Squeaks & Rattles – Noise from Bulkhead  
Brake Line – Install Isolating Pads & Clip

MODEL 1995 MY  
Sedan Range  
VIN  
720001 - 736560

ILLUSTRATION 1

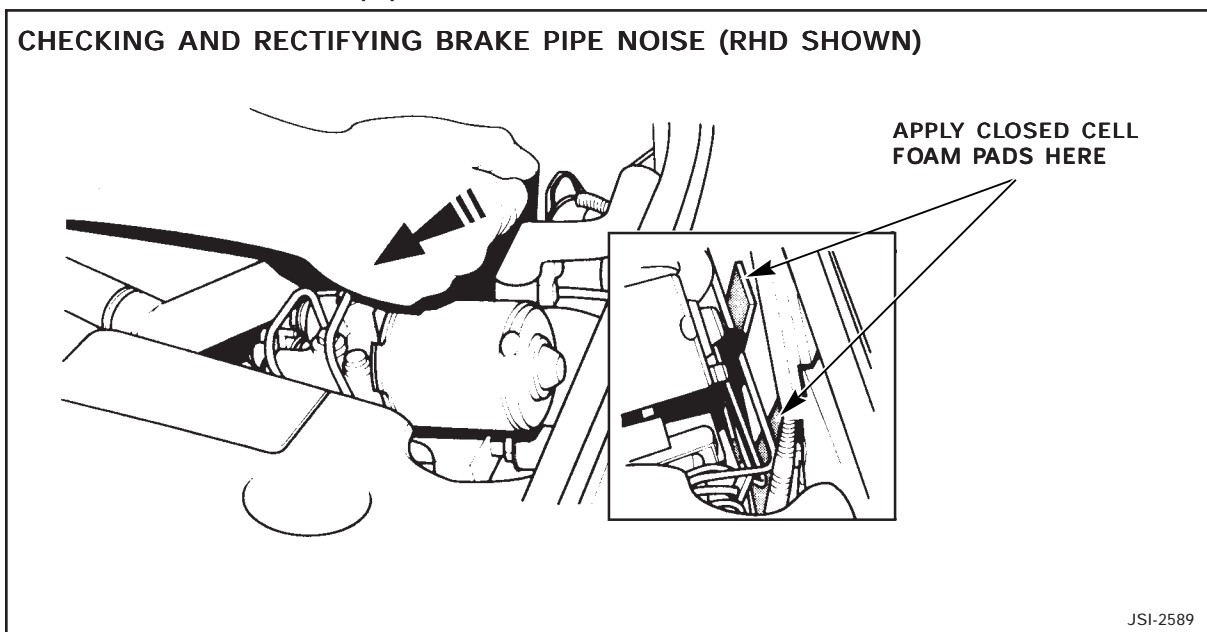
Some 1995 MY Sedan Range vehicles, within the above VIN range, may experience a noise that the customer reports as coming from the right side of the fascia. The source of the noise may actually be in the engine compartment and be caused by contact between a brake line and the bulkhead or between two adjacent brake lines.

If a customer reports a noise from the right side fascia on a 1995 MY Sedan Range vehicle within the above VIN range, check if the noise described by the customer can be reproduced by gently striking the ABS hydraulic unit with the hand as shown in Illustration 1.

1. Clean the surface of the bulkhead and apply two closed cell foam pads (part no. HNA 1210BA) to the locations shown in Illustration 1, to prevent direct contact between the pipes and the bulkhead.
